## Product Change Notice (PCN)

<b>Manufacturer:</b>	<b>For queries:</b>
RAYLASE GmbH Argelsrieder Feld 2+4 82234 Wessling Germany <a href="mailto:info@raylase.de">info@raylase.de</a> <a href="http://www.raylase.de">www.raylase.de</a>	Your customer number: Your contact person: Tel.: +49 8153 9999 699 E-mail: PDN@raylase.de  Date of publication: 30/04/2021 PCN ID/version: 202101-01

CR-0326 | Product Change of M000008231 TS-II-30 [C] V2 SI-[NL]-RA-D1  
 Component: M000008210 Mounting Plate 046, drawing M032582-02

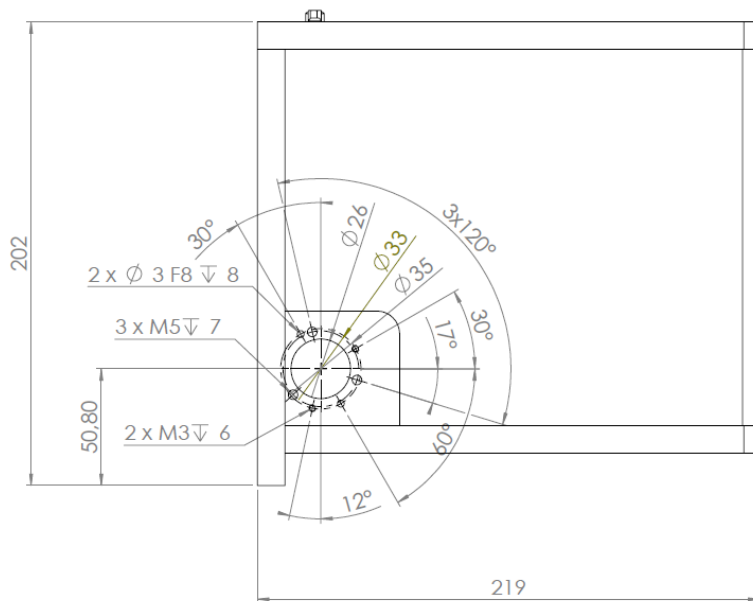
Due to technical improvements regarding the applicability of the product, another thread was added to the opto-mechanical interface of the deflection unit for camera observation (see drawing page 2).  
This does not result in any change or impairment of the previous functionality.

Previous Status Rev 01

New Status Rev 02

A thread M3x6 has been added (see red circles)
